REVISION 4

MONTICELLO NUCLEAR GENERATING PLANT
OFFSITE DOSE CALCULATION MANUAL (ODCM)

TABLE 5.1-1 AND FIGURE 5.1-1 RADIATION ENVIRONMENTAL
MONITORING PROGRAM SAMPLING LOCATIONS

FIGURE 5.1-1
 SAMPLING LOCATIONS
 MONTICELLO NUCLEAR GENERATING PLANT
 RADIATION ENVIRONMENTAL MONITORING PROGRAM

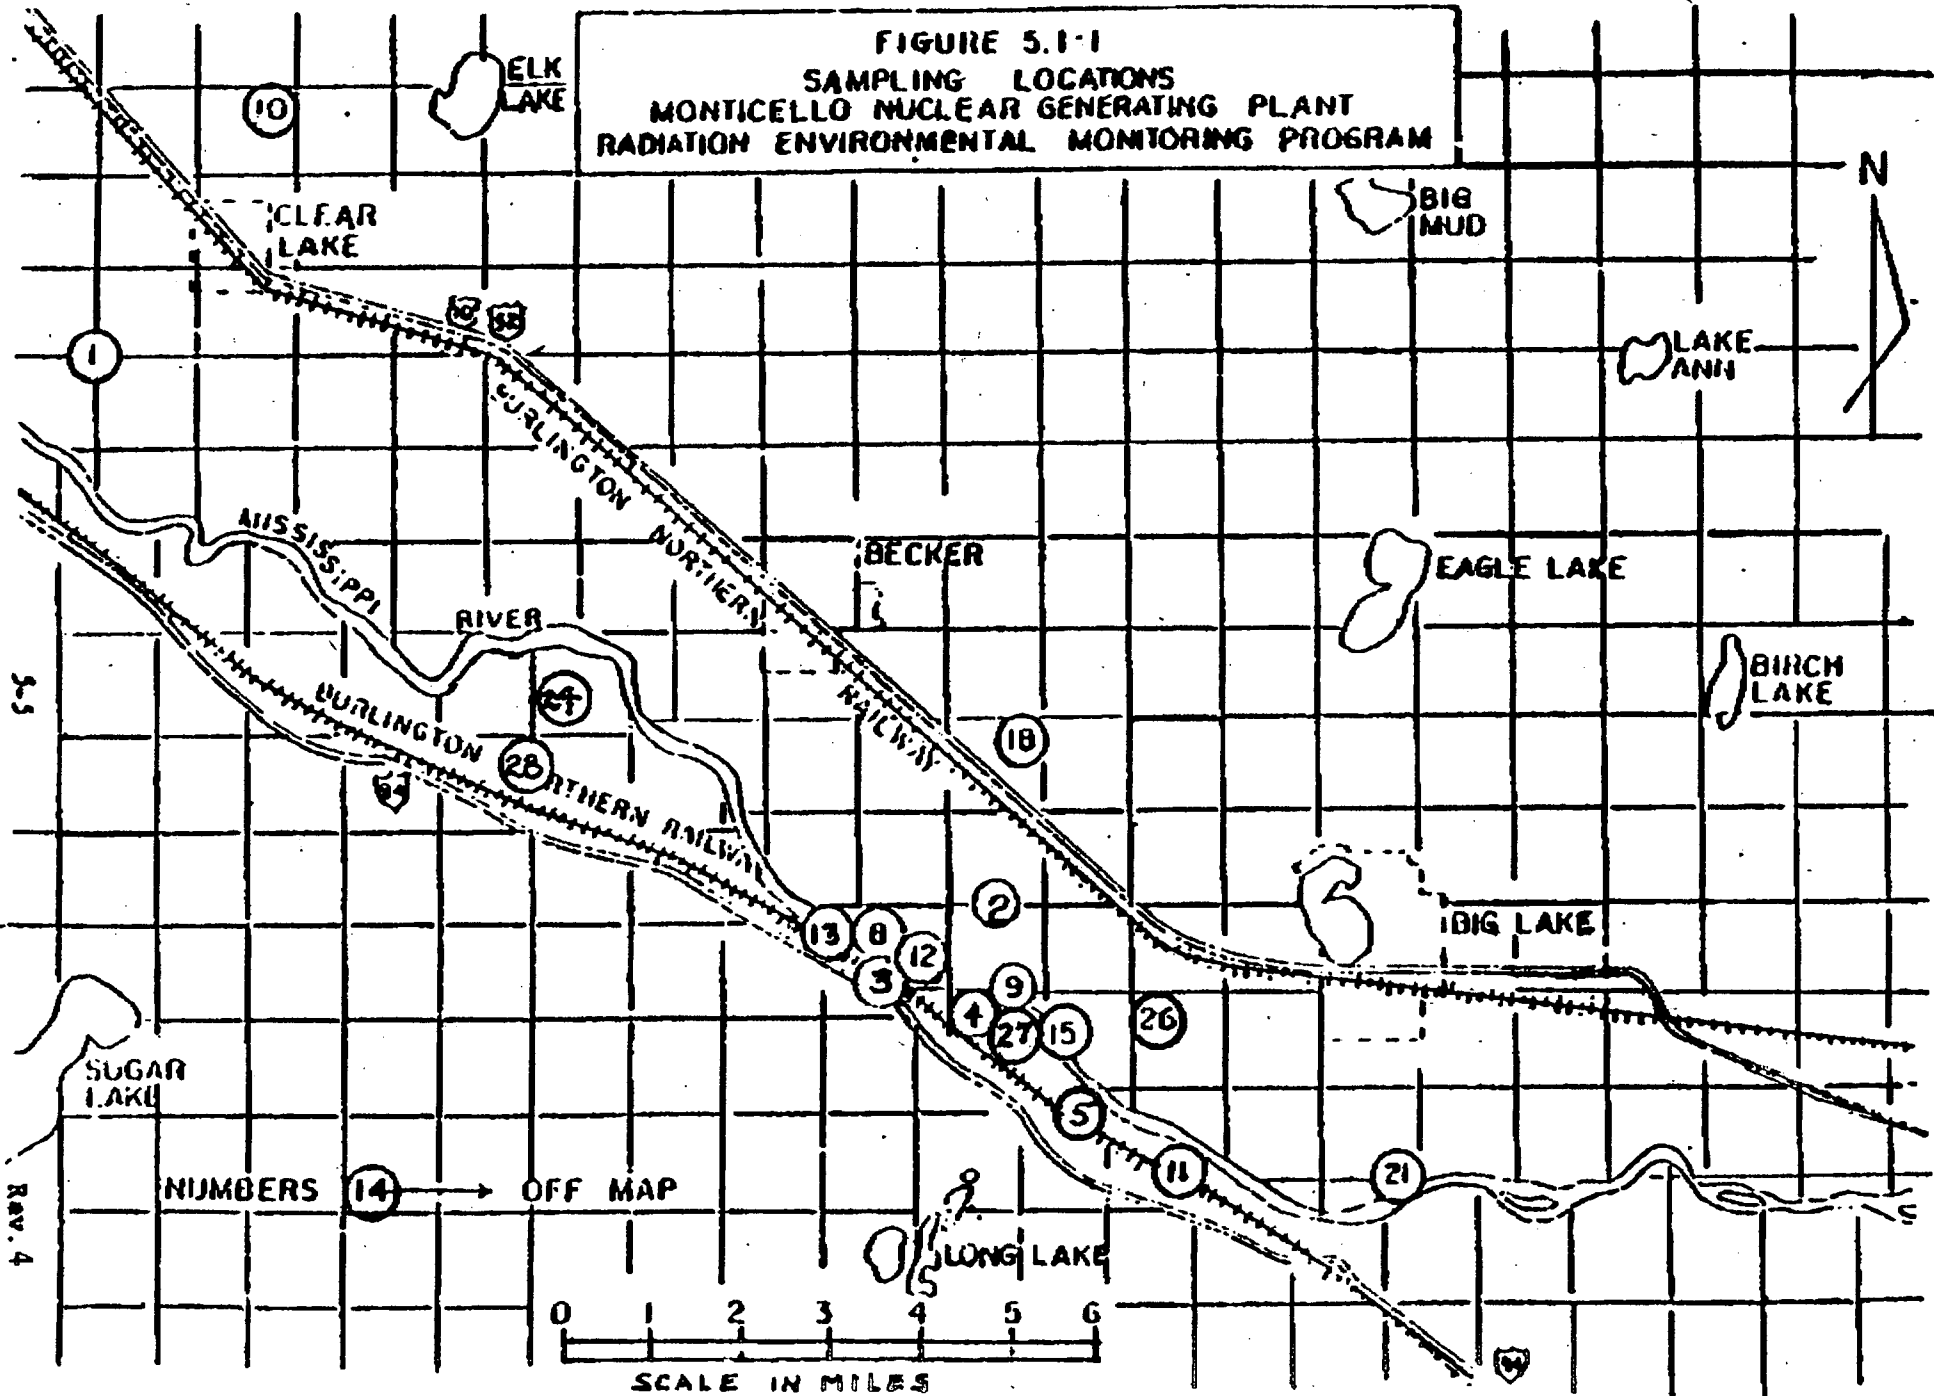
In accordance with the Monticello Technical Specifications, Section 6.5E, Offsite Dose Calculation Manual (ODCM) a change to Table 5.1-1 and Figure 5.1-1 Radiation Environmental Monitoring Program Sampling location is reported.

One of three dairy farms required by the sampling program is located 3.6 miles at 224°/SW from the facility. The dairy farm owner has decided to sell his animals and discontinue the dairy business. In replacing the farm, we used the Dispersion parameters (D/Q) in the ODCM, and the latest Land Use Census for the area to decide to sample milk from two highest D/Q farms. These farms are the Gary Hoglund Farm (3.8 miles @ 300°/WNW) and the Donald Anderson Farm (3.6 miles @ 308°/NW). A lower calculated dose farm deleted from the program is the Witschen Farm (3.2 miles and 260°/W) from the facility.
